RE: **PETITION NO. 1137** – Windham Solar, LLC declaratory ruling that no Certificate of Environmental Compatibility and Public Need is required for the construction, maintenance, and operation of five 1.0 MW Solar Photovoltaic Renewable Energy Generating facilities located at 1 Williams Crossing Road, Lebanon, Connecticut. **Request for Third Amendment.**

Petition No. 1137

Third Request to Amend Declaratory Ruling

Staff Report

Amended Project Site Plan

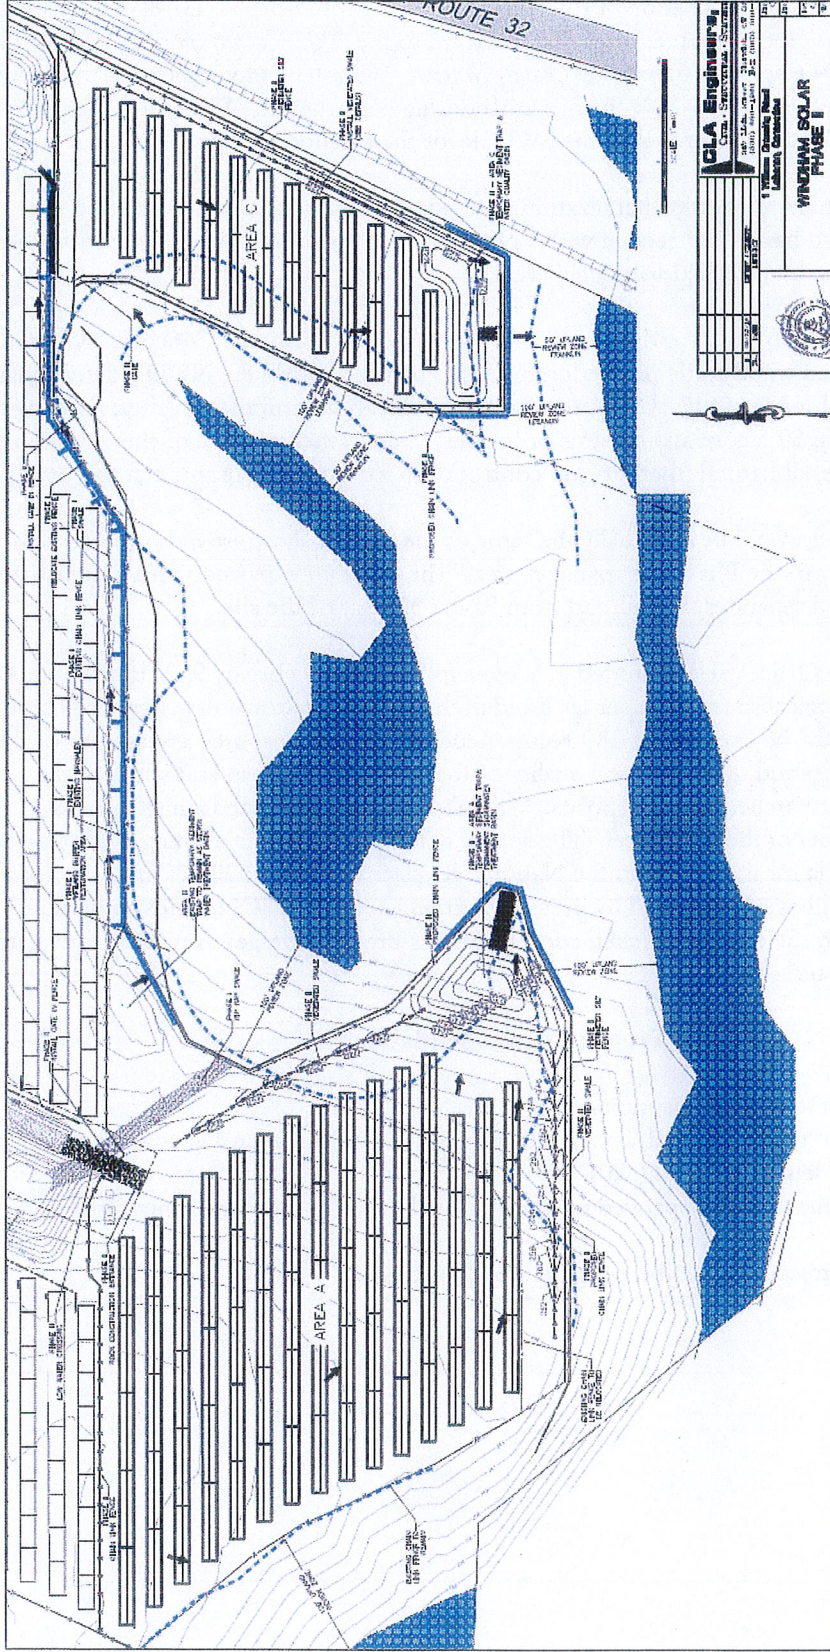
Stormwater features for the Lebanon expansion area consist of a swale and a permanent stormwater detention basin. The proposed perimeter fence line enclosing the expansion area and stormwater detention basin would be approximately 25 feet from W2 at its nearest point. The perimeter fence, solar arrays, and a stormwater detention basin in the Franklin solar field expansion area would be approximately 55 feet from the east edge of W2 and approximately 75 feet from W1.

Phase II Expansion
"Area A" is in Lebanon
"Area C" is in Franklin

1. Implementation of DEEP recommended wood turtle protection guidelines during construction, in accordance with DEEP's letter of June 29, 2017;
2. Submission of a copy of the DEEP-approved updated SWPCP prior to commencement of construction; and
3. Approval of any minor project changes be delegated to Council staff.
